**Marshall Township
Planning Commission**

May 18, 2015 - 7:00 PM

- ❖ Thorn Hill Hotel Complex REVISED; SUB-FIN 15-10; Brush Creek and Knob Road, plans dated 4/14/2015; **deadline: 8/3/2015**
- ❖ Thorn Hill Associates, LP; SP(LD)15-04; Brush Creek and Knob Road, plans dated 4/14/2015; **deadline: 8/3/2015**

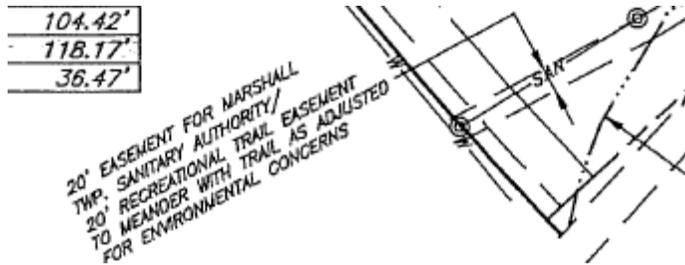
9. All existing and proposed easements should be shown on Recording Plan Sheet 3 Of 4., 174-207.10. The Recording Plan should reference the Conservation Easement as, DB Volume 15831, Page 365. Also, the note, as shown below (SW corner of Lot 3), as provided in the Conservation Easement exhibit, should be added to the Recording Plan and Pedestrian Access Plan, 174-207.10.
